Service Bulletin

S.B. No: 169

Title: INSPECTION OF ENGINE AIR INTAKE DUCT MESH AND ALTERNATE AIR DOOR

FIGURE 1 AIR INTAKE DUCT T67M-50-101

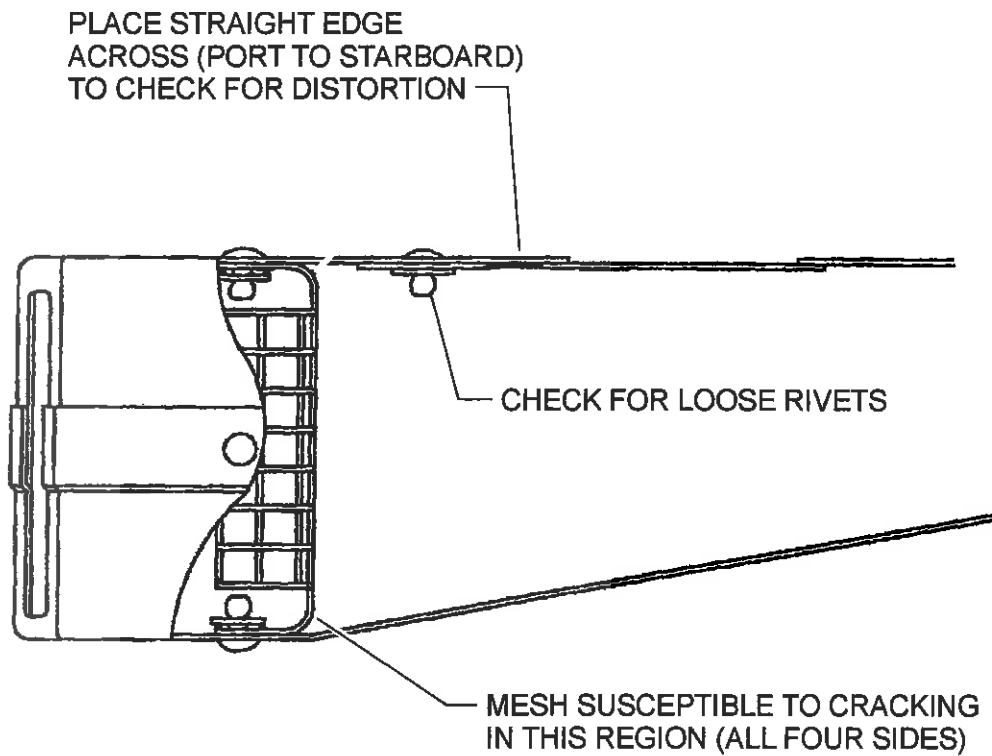
4. Pre Mod M760, part no. T67M-50-101, Ref. Figure 1:
 - 4.1 Inspect mesh within intake duct for cracking and loose retaining rivets.
 - 4.2 Inspect riveted joint between alternate air door and intake duct for condition and any signs of movement. Movement of alternate air door should be smooth throughout its normal travel.

- 4.3 Place straight edge across top of air duct adjacent to the alternate air door retaining rivets and check for distortion. Any distortion of this face will effect the alternate air door operation.

- 4.4 Should inspections at paragraphs; 4.1, 4.2 and 4.3 be considered to be unsatisfactory, then return intake duct assembly to SAL for modification to Post Mod M760B/M933 standard. Incorporation of Modifications M760B and M933 satisfy the requirements of this Service Bulletin.

- 4.5. Should all inspections at paragraphs; 4.1, 4.2 and 4.3 be considered satisfactory, then proceed as follows:
 - 4.5.1 Repeat inspections as required by paragraphs 4.1, 4.2 and 4.3 of this Service Bulletin every 50 flying hours until modifications M760B/M933 are accomplished. Incorporation of modifications M760B and M933 satisfy the requirements of this Service Bulletin.

FIGURE 2 AIR INTAKE DUCT T67M-50-103

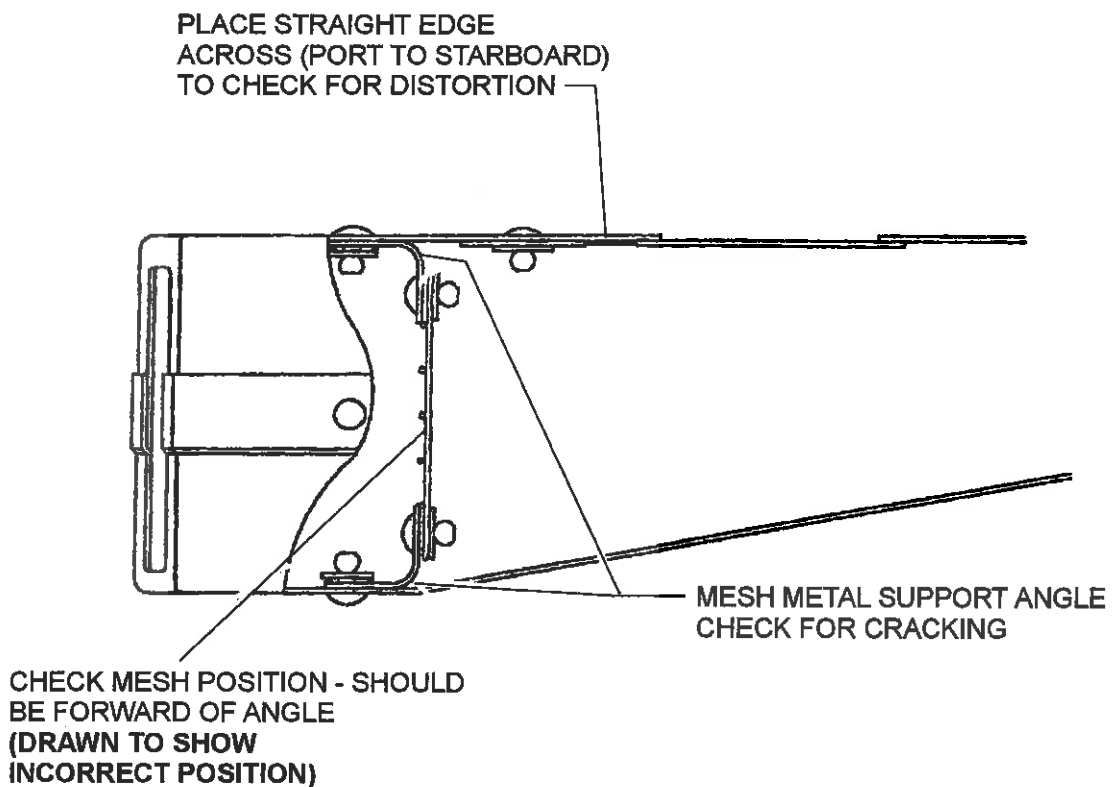
5. Post Mod M760, Part No. T67M-50-103, Ref. Figure 2:
 - 5.1 Inspect aluminium alloy mesh support angle for cracking.
 - 5.2 Inspect for position of mesh and security, should be forward of support angle. If mesh noted to be aft of angle, then check for security every fifty flying hours until Mod M933 incorporated, ref. paragraph 5.3 below.

- 5.3 Should inspection at paragraph 5.1 reveal any cracking in the angle, then angle is to be replaced with composite angle in accordance with Mod M933. Return duct to SAL for Mod M933 incorporation. Incorporation of Modification M933 satisfied the requirements of this Service Bulletin.

- 5.4 If no cracking is found, ref. paragraph 5.1, then inspect every fifty flying hours until modification M933 is incorporated. Incorporation of Modification M933 satisfies the requirements of this Service Bulletin.

FIGURE 3 AIR INTAKE DUCT T67G-50-107

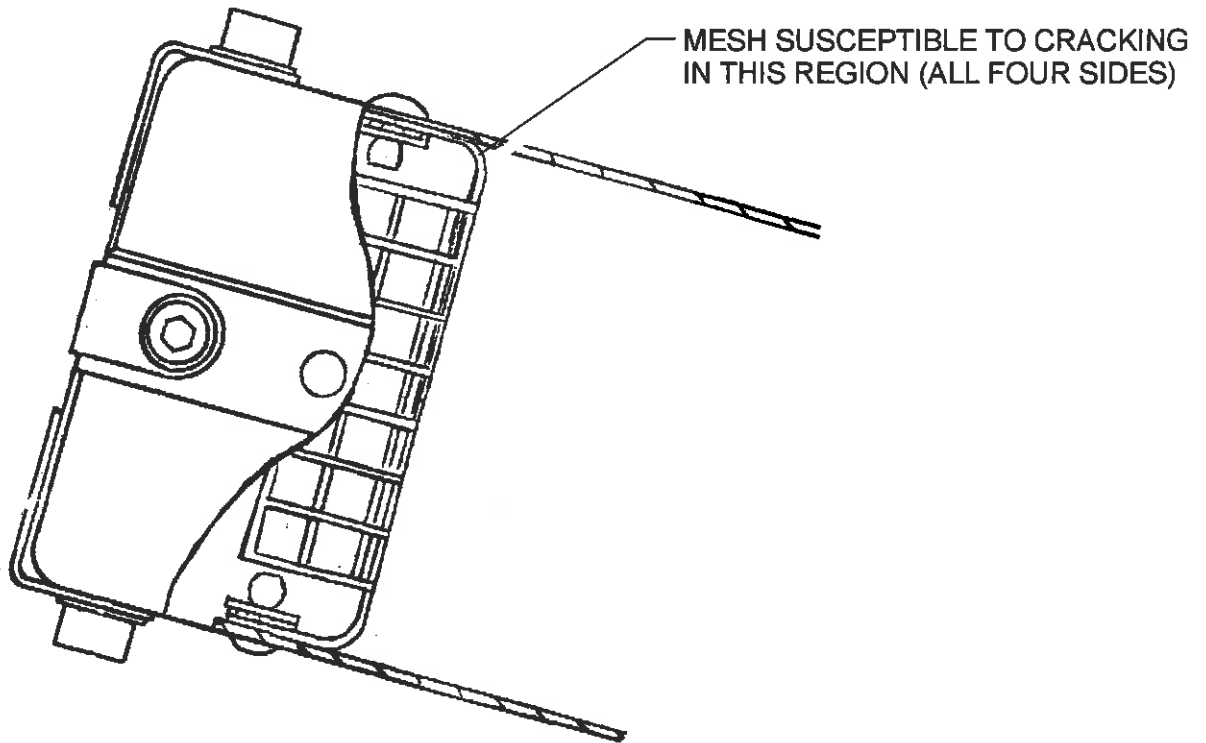
6. Pre Mod M759, part no. T67G-50-107, ref. Figure 3:
 - 6.1 Inspect mesh within intake duct for cracking and loose retaining rivets.
 - 6.2 Should inspection at paragraph 6.1 be considered to be unsatisfactory, then return intake duct assembly to SAL for modification to Post Mod M759B/M933 standard. Incorporation of Modifications M759B and M933 satisfy the requirements of this Service Bulletin.
 - 6.3. Should inspection at paragraph 6.1 be considered to be satisfactory, then proceed as follows:
 - 6.3.1 Repeat inspections as required by paragraph 6.1 of this Service Bulletin every fifty flying hours until modifications M759B/M933 are accomplished. Incorporation of modifications M759B and M933 satisfy the requirements of this Service Bulletin.

FIGURE 4 AIR INTAKE DUCT T67G-50-109

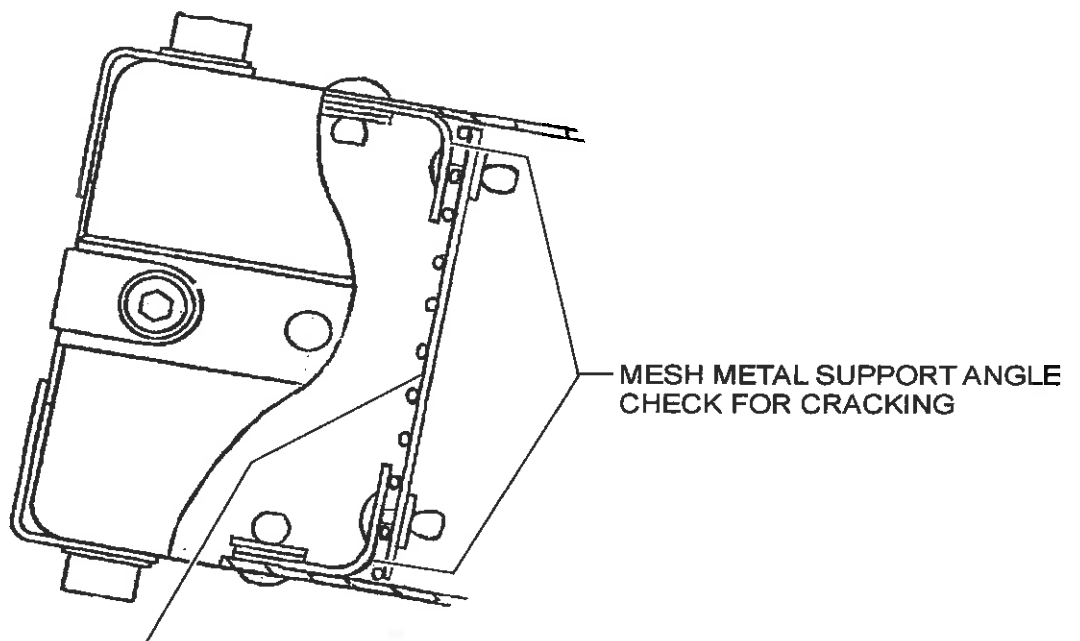
7. Post Mod M759, Part No. T67G-50-109, ref. Figure 4:
- 7.1 Inspect aluminium alloy mesh support angle for cracking.
 - 7.2 Inspect for position of mesh and security, should be forward of support angle. If mesh noted to be aft of angle then check for security every fifty flying hours until Mod M933 incorporated, ref. paragraph 7.3 below.

CHECK MESH POSITION - SHOULD
BE FORWARD OF ANGLE
(DRAWN TO SHOW
INCORRECT POSITION)

- 7.3 Should inspection at paragraph 7.1 reveal any cracking in angle, then angle is to be replaced with composite angle in accordance with Mod M933. Return duct to SAL for Mod M933 incorporation. Incorporation of Modification M933 satisfies the requirements of this Service Bulletin.

- 7.4 If no cracking is found, ref. Paragraph 7.1 then inspect every 50 flying hours until modification M933 is incorporated. Incorporation of Modification M933 satisfies the requirements of this Service Bulletin.
